## ENGINEERING CHANGE ORDER

BOARD NAME <u>TORRENT Power Supply Board</u>	ECO# <b>TRNT-022</b>	DATE <u>6/15/2011</u>
BRD SERL# <u>005-016</u> REV <u>A</u>	ART# <u>TRNT-EL-04-0001-###</u>	
PN# _____      REV _____	_____      REV _____	
ASBLY# <u>TRNT-EL-04-0001</u> REV <u>A</u>	PCB# <u>TRNT-EL-04-1001</u>	REV <u>A</u>
BOM# <u>TRNT-EL-04-4001</u> REV <u>A</u>	SCH# <u>TRNT-EL-04-2001</u>	REV <u>A</u>
COGNIZANT ENGR <u>Peter Moore</u>	CHARGE# _____

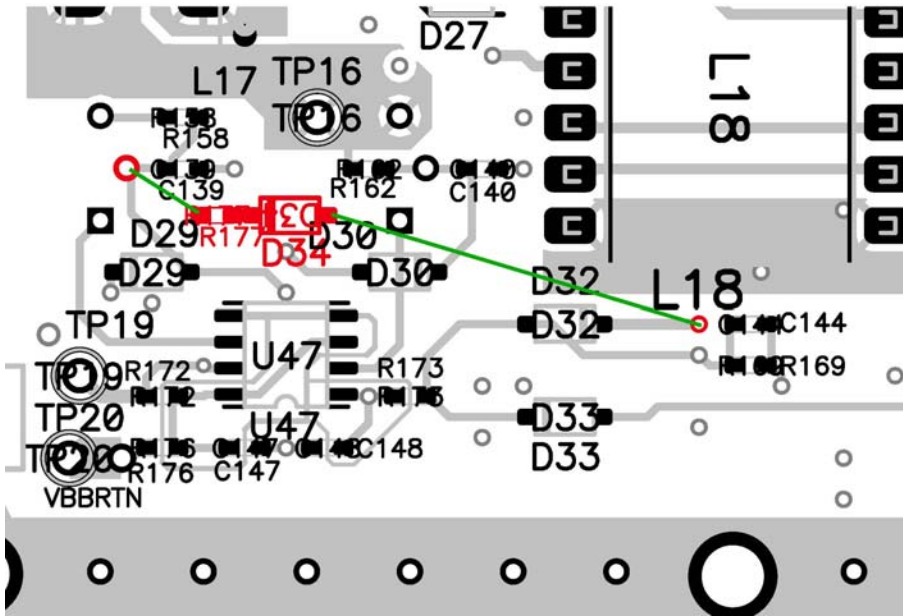
Removes a 20% deadband from the negative Vbb supply control voltage response. This modification provides additional bias to Q8 base when the demanded negative potential is close to GND. Under these conditions, there is insufficient drive to the base of Q8 to supply a 'positive' potential to U47A which is starved of its supply potential.

1. Add a 51.1K Ohm 1% resistor in series with a 1N4148 diode between Vcb+ and Q8 base.
2. Close access to VCB+ can be found at the cathode of D32. Wire the 1N4148 Anode to this node. Use white wire to make connections.
3. Access to Q8 base can be found at the common node between R158 and C139. Wire the resistor to this node and connect to the cathode of the 1N4148 diode.
